From: Robertson, Jean
Sent: Wednesday, November 10, 2010 2:59 PM
To: 'Ann Pool'
Subject: RE: 45-14107 Moo View

Moo View Cow Palace
(Off Season Stockwater)

WATER RIGHT APPLICATION 45-14107

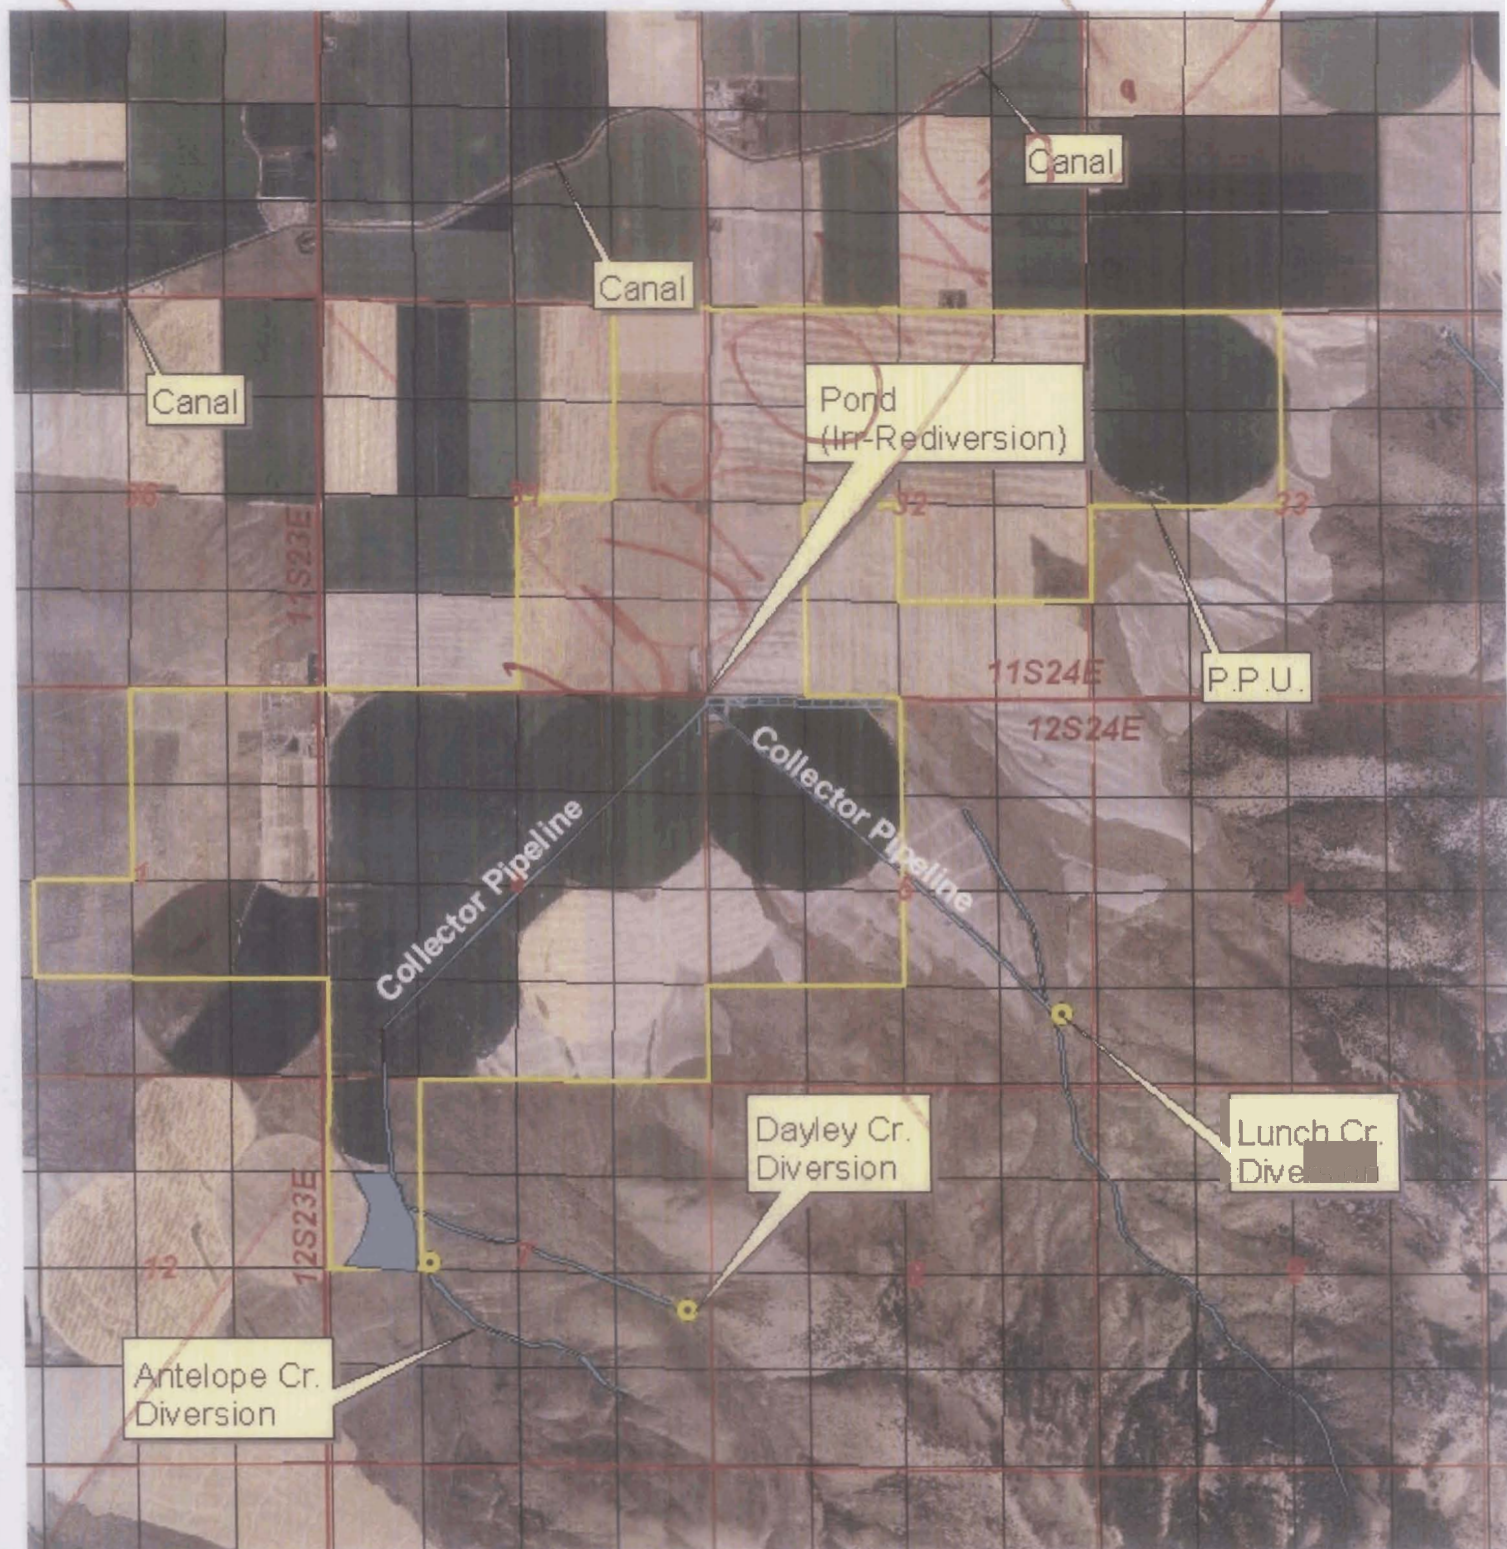
Uh oh...this map does not match the place of use box. I think the problem is between Sections 1 and 12. Your shape includes some QQs in Section 1 but the box shows no pous in Section 1 but some in Section 12 that are not in your shape?

Was off last week and am now starting back with this amended application. I think I need a new map which shows the place of use of all the stock water. As far as I can tell, the map you submitted shows the diversions but doesn't really outline the place of use. I think it will help us know that we got it right if the visual picture is the same as the place of use box so we get everything included that they want. Give me a call if you have any questions or comments. Thanks, Jeanie

Here is the new map... we have some updating issues with ArcView and cannot get the legend to stick, so noted the yellow PPU w/ a caption box... hope this will work ok for you.... let me know if it doesn't print ok and I'll drop a copy by.
